Development Facilitation Team (DFT) – Review Comments

Project No: PR-2020-004218 Date: 7/10/2024 Agenda Item: #2 Zone Atlas Page: F-17

Request: Remodel of existing Chick-Fil-A consisting of drive-thru widening, parking modification, and striping.

Application For: SI-2024-00923 – SITE PLAN DFT

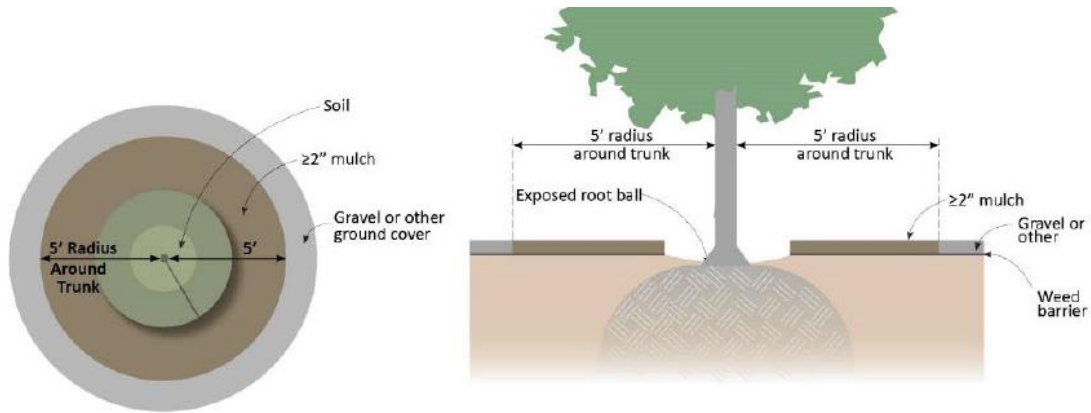
- Per 5-6(C)(5)(e) Organic mulch is required as ground cover under trees within a 5-foot radius around the tree trunk, but not directly against the trunk. In these areas, weed barrier fabric is prohibited. (See figure below.)

A tree planting detail must be added to the Landscape Plan to reflect this requirement.
